Responses to Steve Scott's Comments Made November 21, 2016 on WEST Draft Report from July 27, 2016

Figure 1

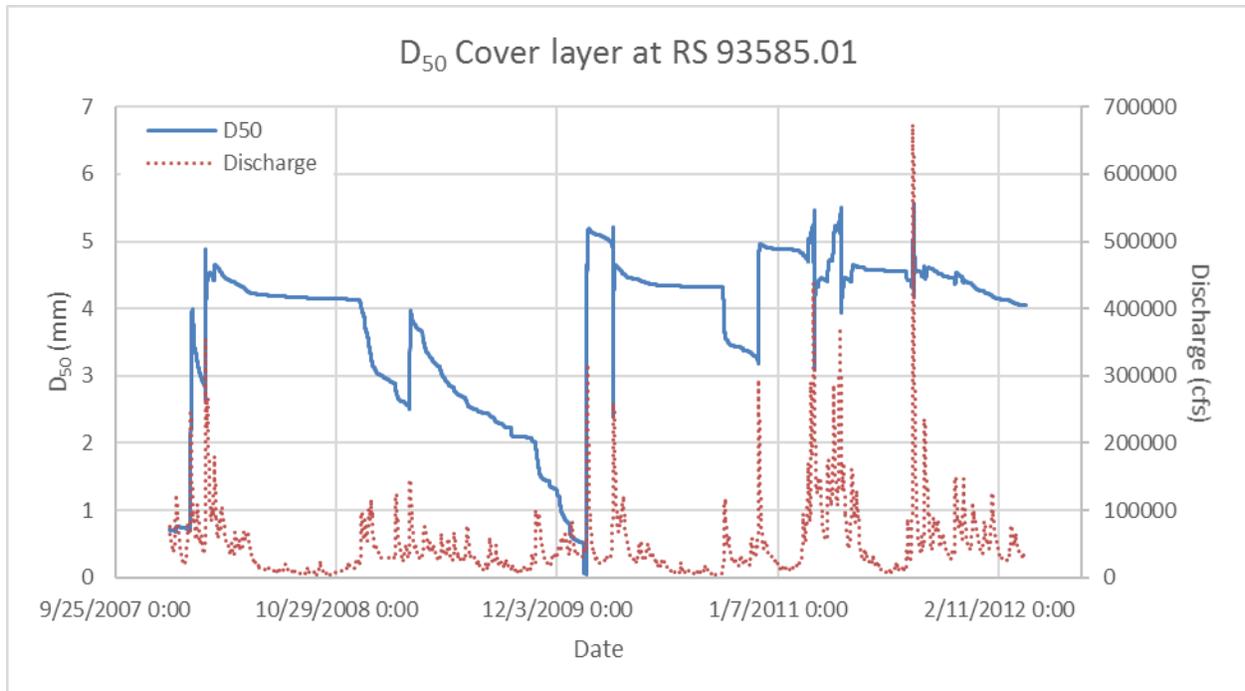
- 3) *“Erosion of the bed mostly occurred in areas consisting of primarily sand, with minimal erosion of areas consisting of a mix of sand, silt, and clay. These mixed sediment areas occurred in channel reaches with the highest velocities and subsequent bed shear for the Tropical Storm Lee event. It is unclear where the reviewer’s information about the sediment mixtures associated with the areas with the greatest modeled velocities came from the WEST model or from other sources. While it is true that the sand size class accounted for most reservoir mass change during Tropical Storm Lee, which suggests that areas of the bed with a greater proportion of sand experienced more scour overall during that event, the median grain size (D_{50}) of the cover layer at each cross section was not well correlated with the modeled velocity at the peak of TS Lee.*

Some bed sediment mixtures varied considerably throughout the simulation, and the state of the bed at a given location often dictated its response to a particular storm event. Figure 1 compares discharge with the modeled D_{50} of the cover layer for a cross section a short distance downstream of Pequea Creek in Lake Aldred for part of the simulation period. The location was chosen due to the presence of very coarse sands and even some fine gravel at the beginning of the simulation, which makes changes in the D_{50} more distinct. The plots show the D_{50} fining during periods of low to moderate flows (there’s little change at very low flows) and coarsening during periods of larger flows as finer size classes are selectively scoured. The cross section experienced three other storm events of around 300,000 cfs or greater during the year leading up to TS Lee, so the bed was already very coarse when Lee occurred. If the modeled sediment mixture varied so significantly for a single cross section over the course of the simulation, and responded differently to changes in velocity and shear stress depending on the pre-storm bed state, it is probably not advisable to draw general conclusions about the relationships between bed sediment mixtures and hydraulic factors based on TS Lee alone. (Also, this armoring may have limited scour during the event, again illustrating the sensitivity of net mass change during large storms to bed state.)
